**CITY OF KLAMATH FALLS
PLANNING COMMISSION**

**Staff Report
1-S-09**

Request for recommendation of approval to City Council for Tentative Subdivision Tract 1530 – Cortez Ridge

- 1) Tentative Subdivision Plat
- 2) Street Layout for Land West of Cortez Ridge
- 3) Letter of Opposition from Rev. Martin B. Jocks

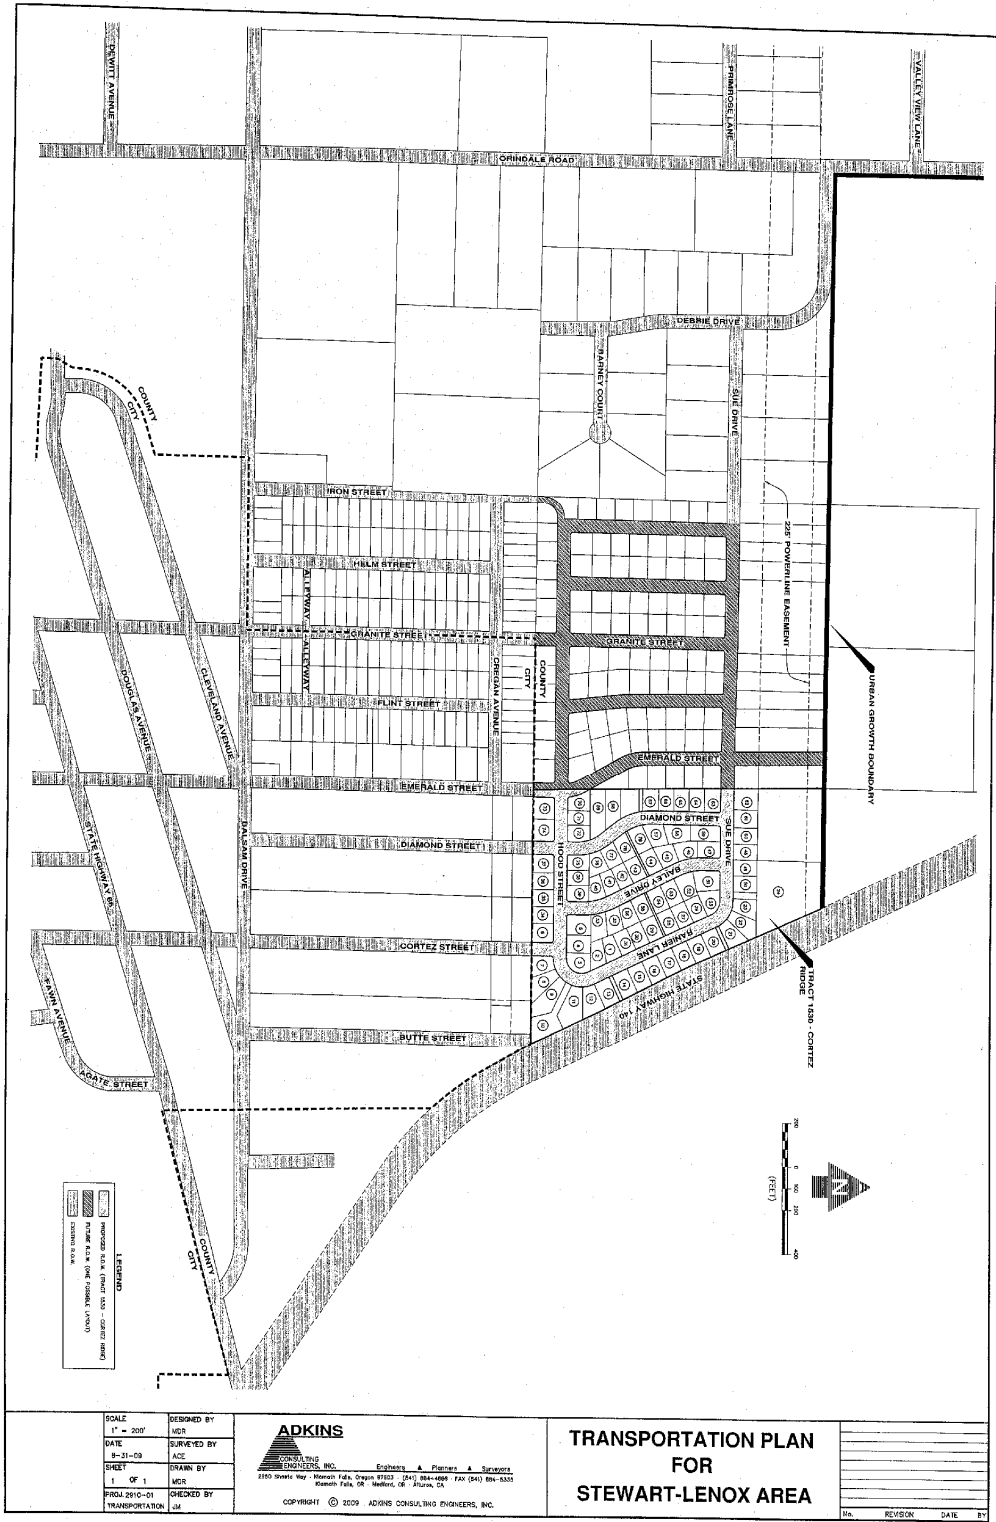
3. The north end of existing Diamond Street shall have an approved City barricade installed by this development and shown in detail on the engineering design/construction plans and generally noted on this Tentative Subdivision Plan. ((Revised 9/2/09: The updated Tentative Plan is now showing Diamond Street as being connected to the south boundary of this proposed subdivision. The City barricade is not required per this change.))

4. Define the point location, by lot corner, of the street name change from Rainier Lane to Whitney Avenue. ((Revised 9/2/09: Whitney Avenue was changed to Sue Drive to plan for a future connection with the existing Sue Drive west of this subdivision. Due to the directional changes in the internal streets, the street name changes from Sue Drive to Rainier Lane and Rainier Lane to Hood Street shall be shown on the engineering design construction plans, with the location of the street signs, so it is clearly depicted on those plans for proper addressing of the lots.))

5. Per Community Development Ordinance (CDO) 11.810(5a), the radii of curves of the proposed streets are missing. ((Revised 9/2/09: The radii of the curves at the street intersections are still not shown on the revised Tentative Plan, but shall be shown on the engineering design/construction plans and shall meet our Public Works Engineering Standard 8-5.3.6.))

6. Clarification of existing easement, shown on the west boundary of this proposed subdivision plan, needs to be identified regarding its future status. Will it remain and how will it be used and maintained, or will it be released prior to plat recording of Phase V? The easement encumbers 8 residential lots, an Alley and a Detention Pond. Provide some detailed information. ((Revised 9/2/09: The revised Tentative Plan has properly addressed this item regarding the easement.))

7. Above items 3 through 6 shall be addressed on a revised Tentative Plan before tentative plan approval. The approved tentative plan, along with the conditions, is used as the guide for staff to follow when reviewing and approving the final plats of this subdivision. ((Revised 9/2/09: Items 3 through 6 have either been addressed on the revised Tentative Plan or will be shown on the engineering design/construction plans.))

4. The applicant shall extend Butte Street to connect to Hood Street. This extension and connection shall be shown on the revised Tentative Plan. The Community Development Department and the Public Works Department both support this requirement.

5. The applicant shall show the radii of the curves (per Community Development Ordinance (CDO) 11.810(5a)) of the proposed streets at the street intersections on a revised Tentative Plan. They shall also be shown on the engineering design/construction plans and shall meet the Public Works Engineering Standard 8-5.3.6.

7. The applicant shall define the point location, by lot corner, of the street name change from Sue Drive to Rainier Lane. Due to the directional changes in the internal streets, the street name changes from Sue Drive to Rainier Lane and Rainier Lane to Hood Street shall be shown on the engineering design construction plans, with the location of the street signs, so it is clearly depicted on those plans for proper addressing of the lots.
